Correspondence Reference: CRWF-2-AEC-0021

**Crudine Ridge Wind Farm (SSD-6697) MOD1| Audit Response**

A full independent audit was undertaken of the Crudine Ridge Wind Farm (CRWF) pursuant to Condition 8 and 9, Schedule 5 of SSD 6697 MOD1. The audit was undertaken on site by SNC Lavalin (SNC) on 10 and 11 September 2019. The audit team comprised Richard Peterson and Georgia Voura from SNC, Crudine Ridge Wind Farm was represented by Patric Millar.

PROJECT CRUDINE RIDGE WIND FARM  
 TITLE Progressive Erosion Sediment Control Plan  
 Wind Farm - Sheet 1  
 DRAWING No. ZX109-DWG-7511-1  
 REV 0

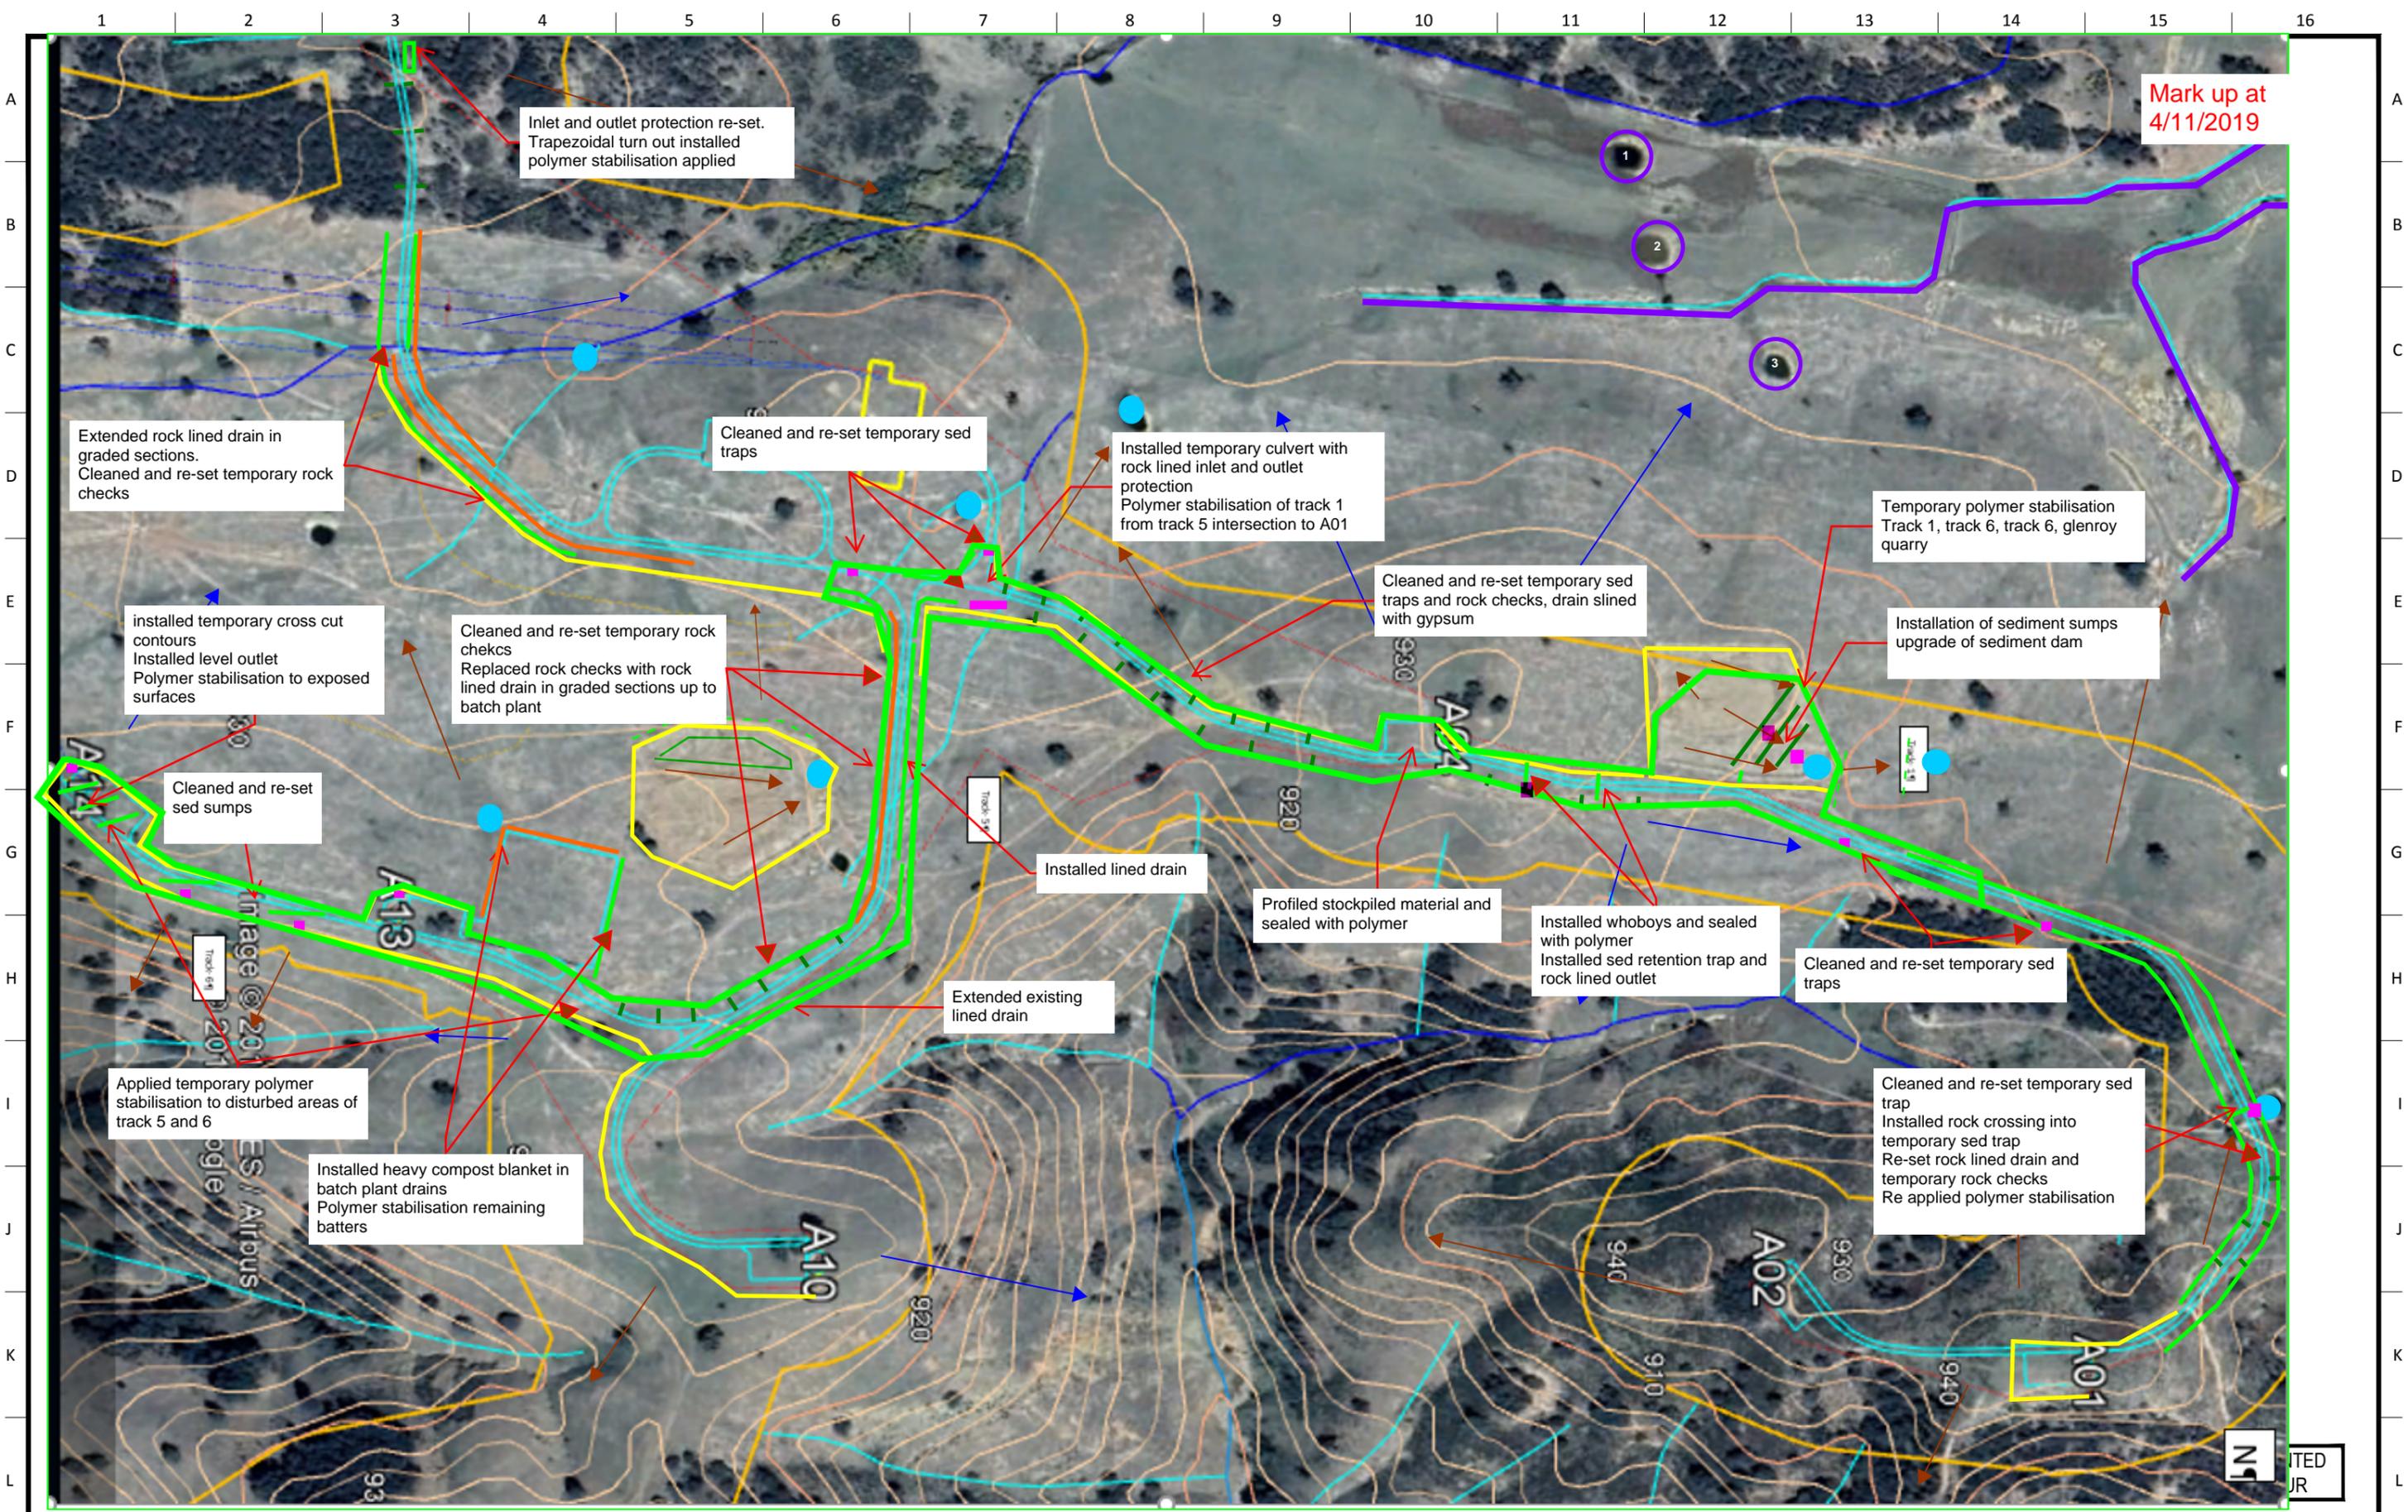
Mark up at  
4/11/2019

Cleaned and re-set temporary rock  
chekcs  
Replaced rock checks with rock  
lined drain in graded sections up to  
batch plant

Installed heavy compost blanket in  
batch plant drains  
Polymer stabilisation remaining  
batters
